*LEOMINSTER*  
*LOCAL PROTECTION PROJECT*

**MONOOSNOC BROOK**  
**LEOMINSTER, MASSACHUSETTS**

*FINAL*  
*ENVIRONMENTAL STATEMENT*  
*& 404 EVALUATION*

JANUARY 1980

PHOTO LOCATIONS

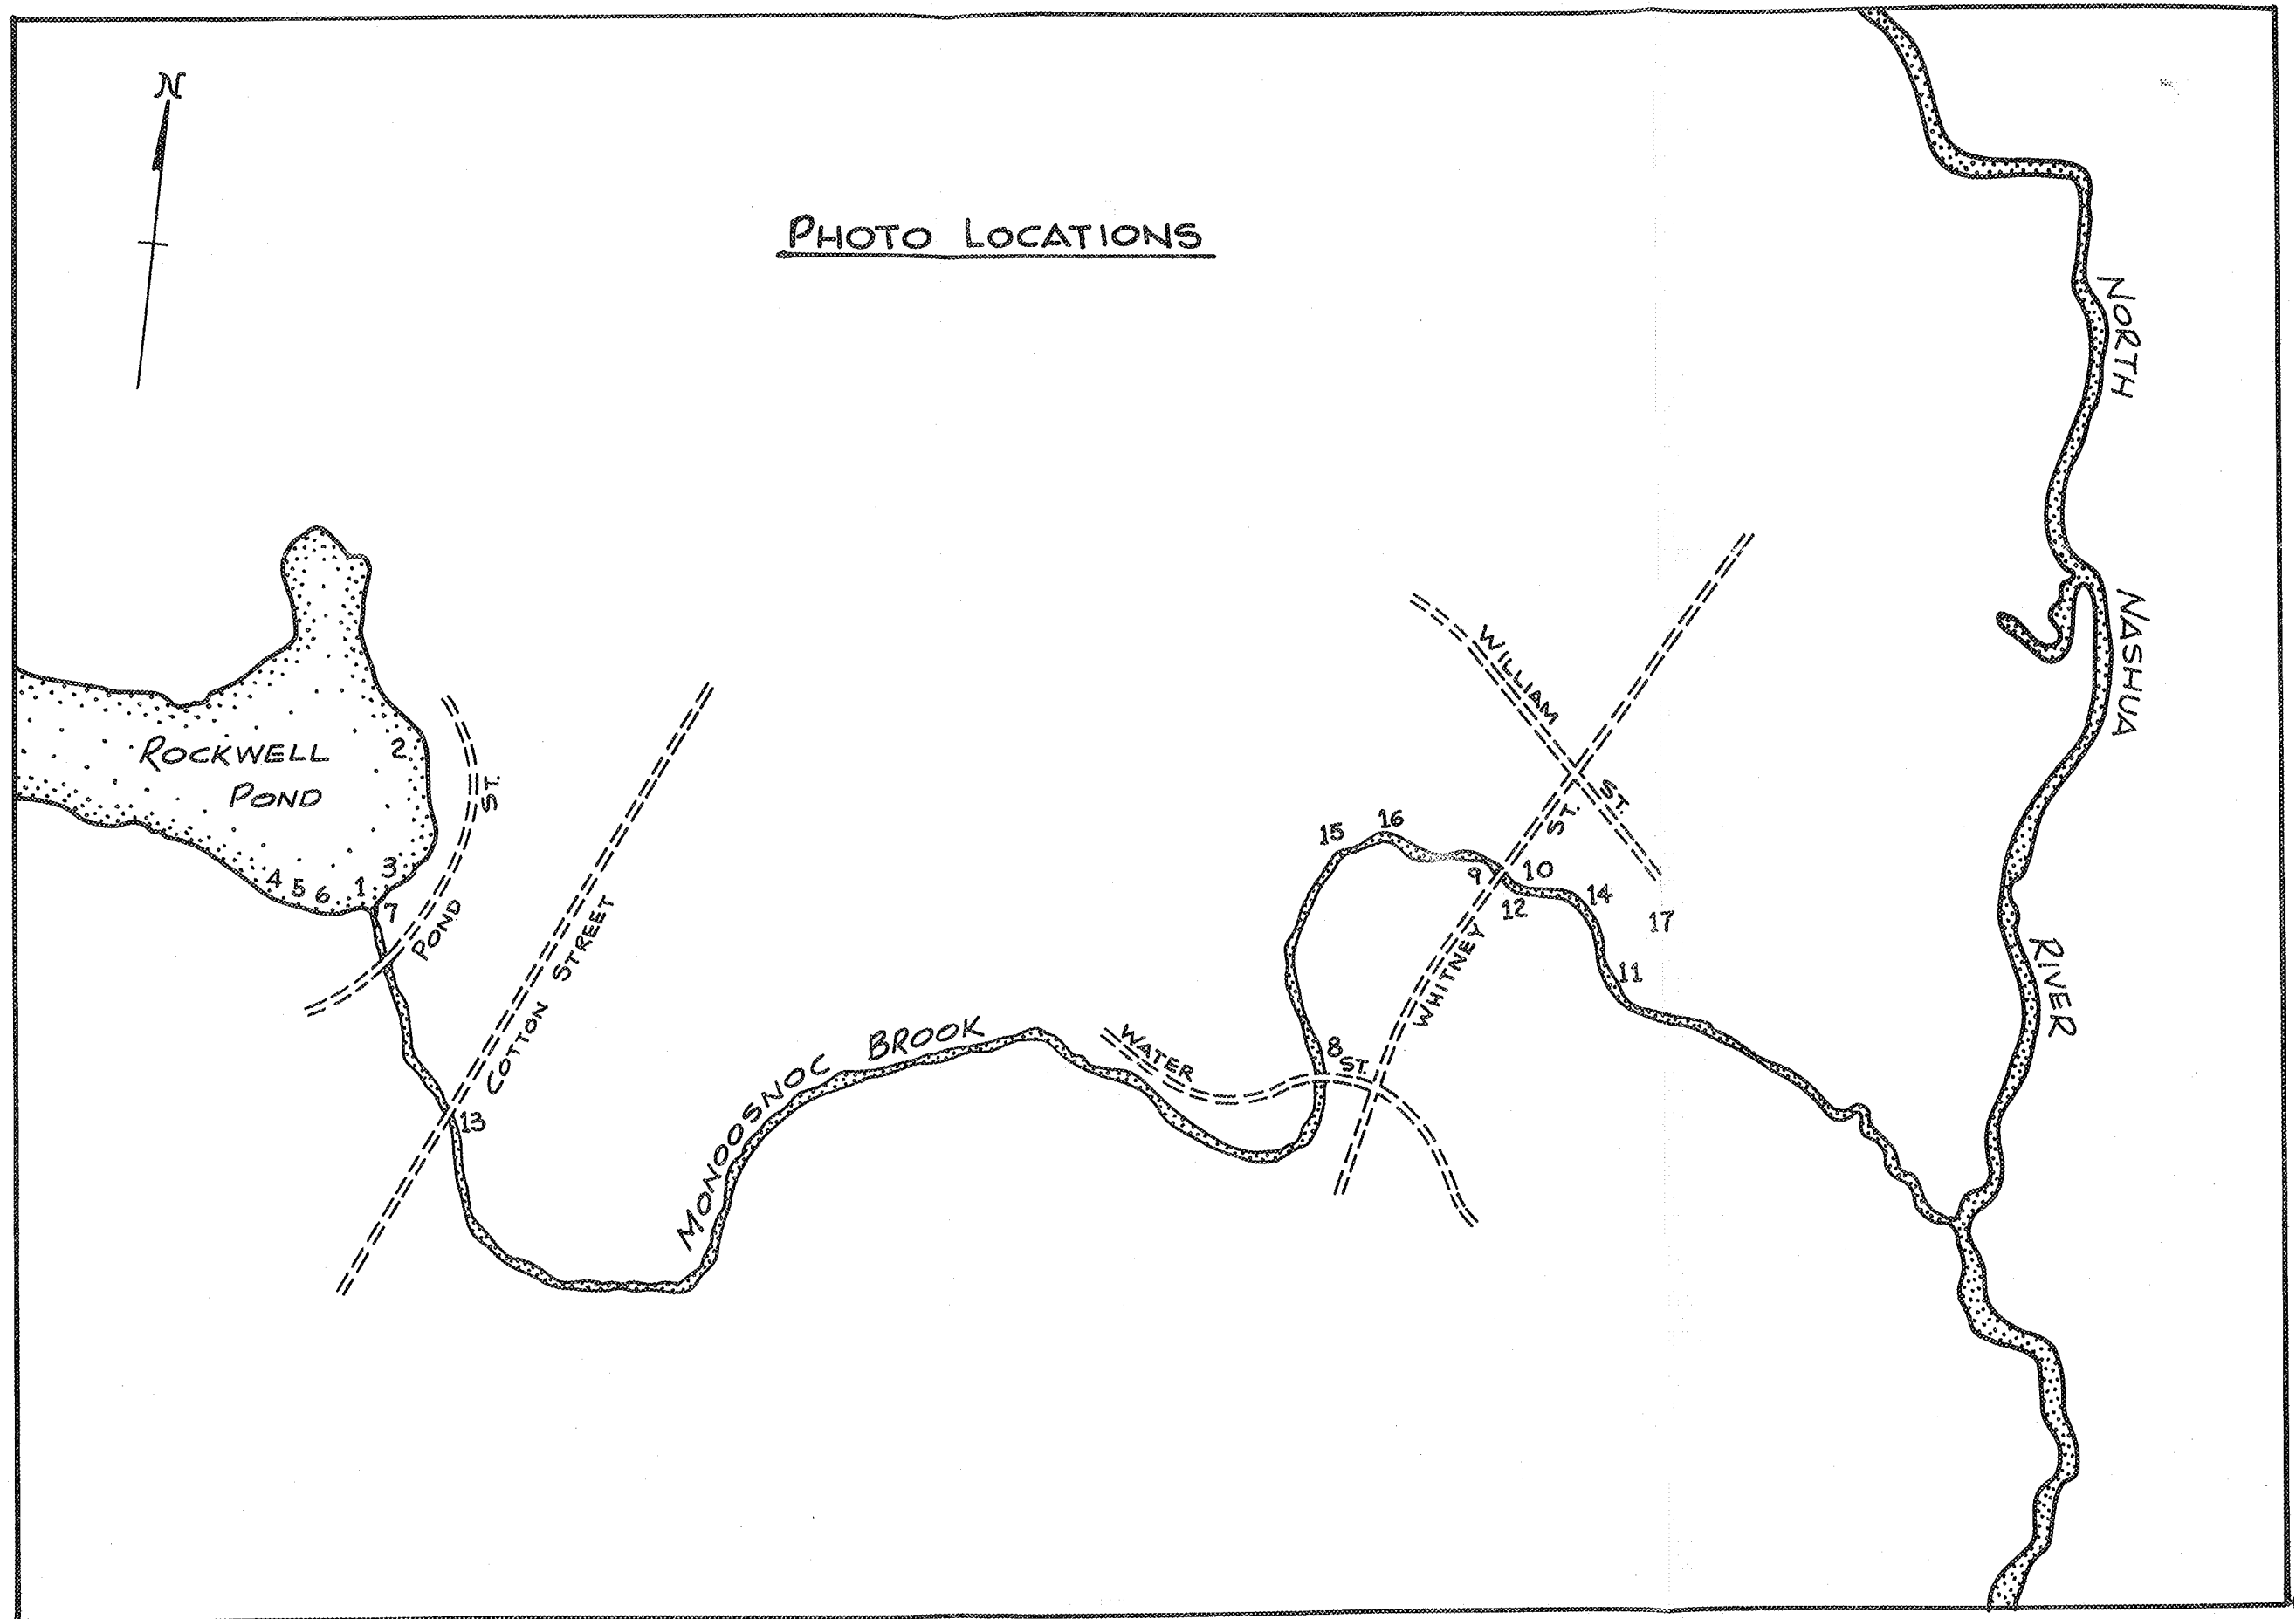
We also noted that Photo 18 location is not identified on sheet entitled "Photo Locations".

## DISSOLVED OXYGEN DEPLETION CURVE FOR WATER STORED BETWEEN DISCHARGE EVENTS

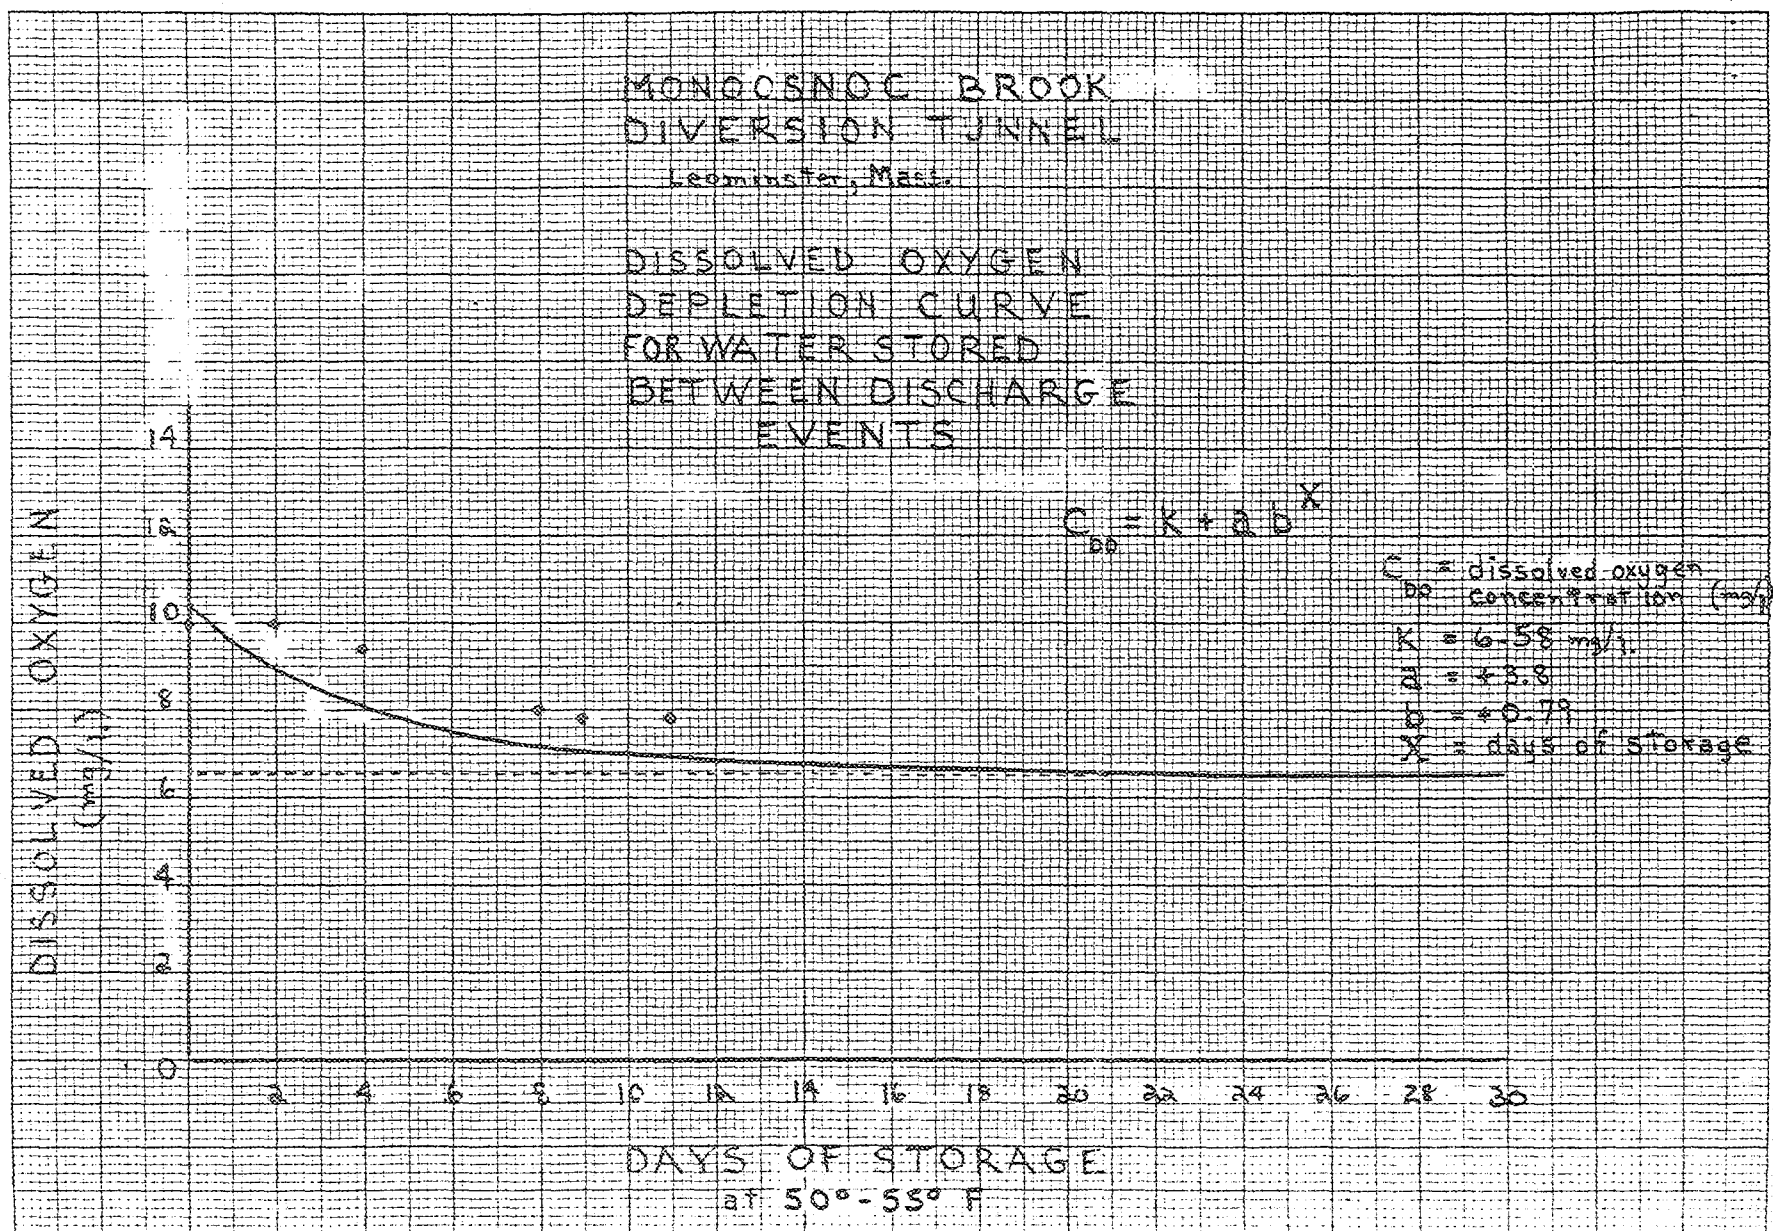
Comment: "The discussion of the DO characteristics of water trapped in the tunnel between diversions (page 4-2) is cursory and very unsatisfactory. Aside from its apparent experimental errors, the approach described in the appendix is oversimplified and does not consider such conditions as the high BOD and COD of urban runoff; the oxygen demand decaying organic matter, such as leaves, which may be left in the tunnel between storms; and a series of storms large enough to produce flow into the tunnel, but not large enough to flush out the tunnel completely. Many towns in Massachusetts have experienced pollution problems from unmaintained catch basins, and the proposed tunnel represents the same problem magnified enormously. Much more thought and study should be given to the biological and chemical impacts of the tunnel on downstream waters."

Comment: "The discussion of the DO characteristics of water trapped in the tunnel between diversions (page 4-2) is cursory and very unsatisfactory. Aside from its apparent experimental errors, the approach described in the appendix is oversimplified and does not consider such conditions as the high BOD and COD of urban runoff; the oxygen demand decaying organic matter, such as leaves, which may be left in the tunnel between storms; and a series of storms large enough to produce flow into the tunnel, but not large enough to flush out the tunnel completely. Many towns in Massachusetts have experienced pollution problems from unmaintained catch basins, and the proposed tunnel represents the same problem magnified enormously. Much more thought and study should be given to the biological and chemical impacts of the tunnel on downstream waters."

Comment: "4.09-4.11 p. 4-2 A more complete dissolved oxygen (D.O.) study should be performed - more samples - a longer time period of analysis. Perhaps, one sample for each test would control the problem of introduction of oxygen into the samples. How would the Corps redesign the experiment to limit the impact of the introduction of oxygen into the water samples during testing: Please explain the correlation between the data points in Fig. 1

"What is your response to this statement? When you redesign this experiment, as appears to be necessary considering the scattering of the data points listed on Table 2 on p. A-14 of the appendix, should tests for D.O. also be run on samples containing organic matter and on samples containing other sources of pollution as well as on samples from the vicinity of the site of the planned inlet for the tunnel? Why? Would you please explain the lack of correlation between the data points in Table 2 and data points in Fig. 1 on p. A-15 of the appendix!"

What is your response to this statement? When you redesign this experiment, as appears to be necessary considering the scattering of the data points listed on Table 2 on p. A-14 of the appendix, should tests for D.O. also be run on samples containing organic matter and on samples containing other sources of pollution as well as on samples from the vicinity of the site of the planned inlet for the tunnel? Why? Would you please explain the lack of correlation between the data points in Table 2 and the data points in Fig. 1 on p. A-15 of the appendix?

Response: The Corps appreciates the State's apprehension over the dissolved oxygen test. However, we still believe the results give a fairly good approximation of the conditions that might result from retaining water in the tunnel. To explain our position, it might be helpful to theoretically analyze how much organic matter would be required to completely denude the tunnel's water of dissolved oxygen, to determine the amount of material required to lower the dissolved oxygen to 6.6 mg/l, and to determine the amount of organic material that might realistically be expected to accumulate in the tunnel.

Between diversions, the tunnel will retain 360,000 cubic feet of water; this is equivalent to 10,162,800 liters of water. Assume that the dissolved oxygen content of the pond's waters is 8.5 mg/l (this is the initial amount found in our study), multiplying this figure by the number of liters, then the total milligrams of dissolved oxygen is 86,383,800. The ratio of oxygen consumed to organic matter is 1:88.\* That is, 1 milligram of oxygen can decompose 88 milligrams of organic matter. Then to determine the amount of organic matter necessary to completely consume the oxygen in the water multiply 86,383,800 by 88. The result is 7,601,774,400 mg; that is equivalent to 16,762 pounds. In other words, it would require over 8 tons of material to completely deplete the dissolved oxygen.

However, to further insure that the position presented is correct, a more detailed study will be conducted during the design phase, as is stated in the last sentence of the first paragraph of the study. Also, a low flow gate would be provided on the Rockwell Pond intake structure to allow for flushing of the tunnel if it becomes necessary.
